# Recall Bulletin

## PRODUCT SAFETY RECALL

**SUBJECT:** Power Lift Gate Prop Rod Recovery

**MODELS:** 2008-2012 Buick Enclave  
2009-2012 Chevrolet Traverse  
2007-2012 GMC Acadia  
2007-2010 Saturn Outlook  
Built Prior to March 10, 2012 Equipped with Power Lift Gate (TB5 or E61)

## Lift Gate Strut Orientation

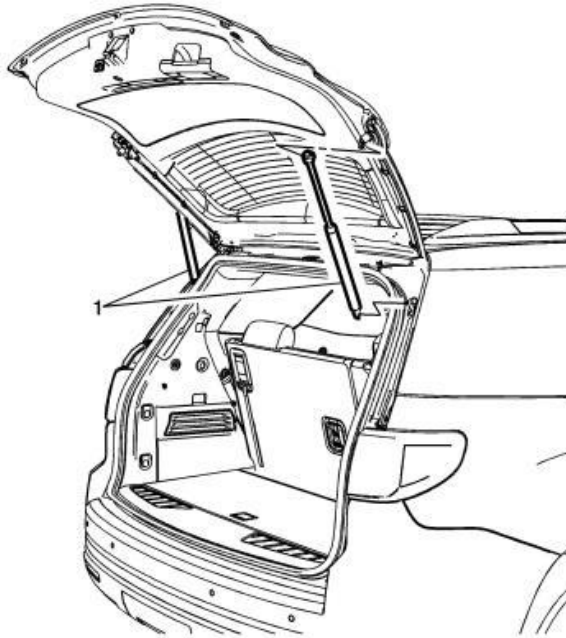
**Note:** GM engineering has determined that improved durability of the lift gate strut can be realized by installing the strut assembly with the rod end facing downward (attached to the lift gate) when the lift gate is in the closed position. In this orientation, dust and dirt does not collect on the strut housing to rod seal, which can cause wear on the seal.

**Note:** When replacing or repositioning the lift gate struts, install the strut assembly with the strut body end attached to the vehicle body and the rod side attached to the lift gate (1).
